Model: Model PL-P2L		Date: 20-Dec-07	No.: MG162001
Modified Article: Regist Ground Spring		Prepared by: H.K.	
From: 1st Tech. Support Sec. Service Support Dept.			
Reason for Modification:	<input type="checkbox"/> Parts catalog correction <input type="checkbox"/> Vendor change <input checked="" type="checkbox"/> Other <input type="checkbox"/> To facilitate assembly <input type="checkbox"/> To improve reliability <input type="checkbox"/> To meet standards <input type="checkbox"/> Part standardization <input type="checkbox"/> Product Safety ()

Model: Model PL-P2L		Date: 28-Mar-08	No.: MG162002
Modified Article: Main Motor		Prepared by: H.K.	
From: Technical Service Dept., GTS Division			
Reason for Modification:	<input type="checkbox"/> Parts catalog correction <input type="checkbox"/> To facilitate assembly <input type="checkbox"/> Part standardization	<input checked="" type="checkbox"/> Vendor change <input type="checkbox"/> To improve reliability <input type="checkbox"/> Other	<input type="checkbox"/> To meet standards ()

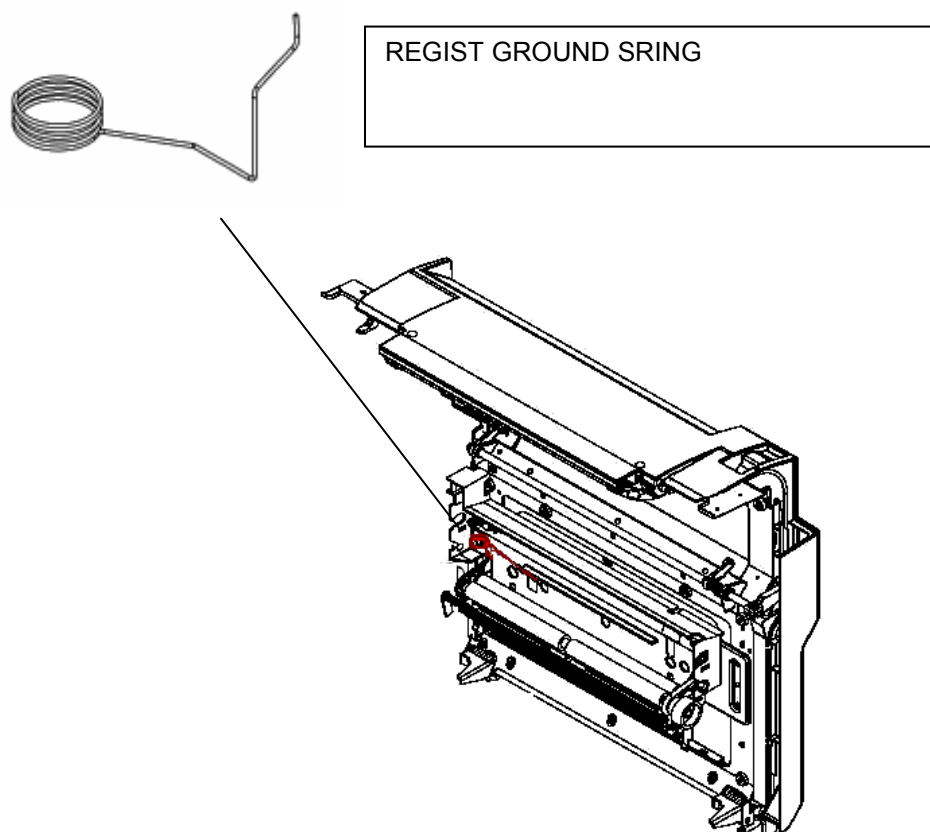
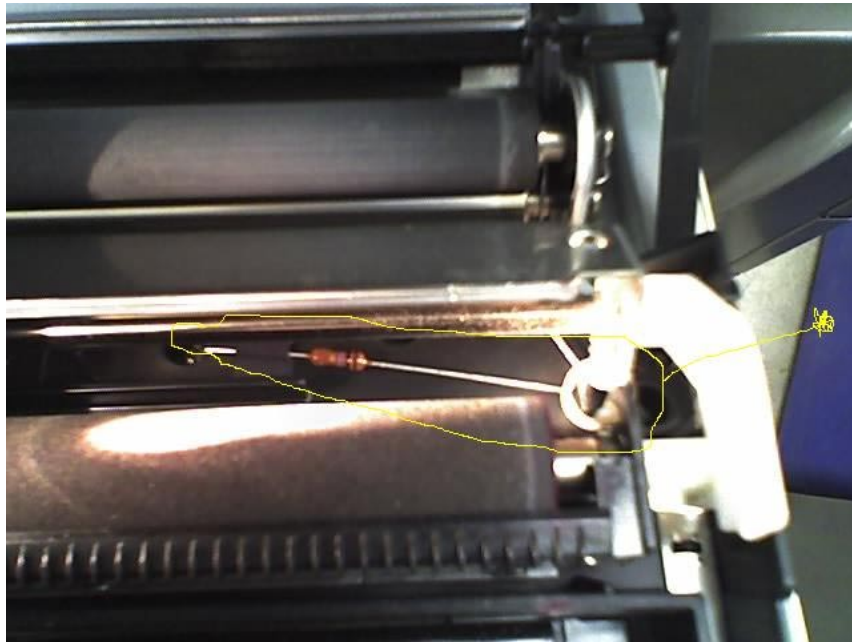
Old part number	New part number	Description	Q'ty	Int	Page	Index	Note
	V121382	REGIST GROUND SRING	0 - 1		7	*13

Change: The part in the table was added.

Reason: Requests were received from the field.

Important: Handle this spring carefully. Make sure not to deform or bend the spring, as this can cause jams, noise, or poor image transfer.
